# SERVICE BULLETIN NO. MSB-AE50R-003

Sub Assembly Rotor & Pulley - R1A-91-100-000 (E R1 B 034)

Fixation of the grub screws in the generator rotor assembly and identification of possible relative movement between the belt pulley and the rotor.

Figure 2: Loose scrub screws

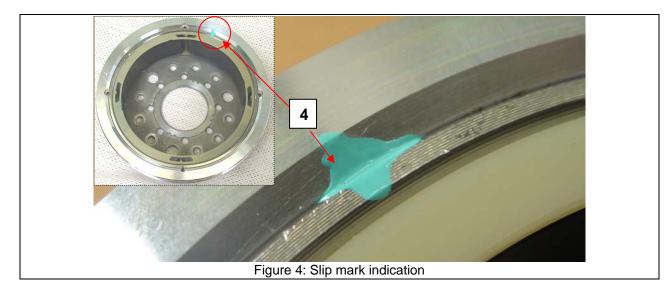
□ Identify if a twist between the belt pulley and the rotor is evident or grub screws got loose [Figure 1] or are missing.

If the grub screws are missing or not properly screwed the following maintenance action is required:

- Remove all grub screws [Figure 1] in the generator rotor assembly.
- ⇒ Clean the holes with ACETON, use new scrub screws M4x5 (DIN 913).
- Screw in the grub screws as far as possible.
- ⇒ The new scrub screws are 3mm shorter than the original assembled scrub screws. Use LOCTITE "Hysol" 3450 two component epoxy adhesive. Fill the thread above the scrub screw consistent with the adhesive to avoid unbalanced mass during operation [Figure 3]. Make sure that the adhesive enters the thread and cured according the product description sheet before operation.
- Remove overlapping adhesive.
- Clean the working area.
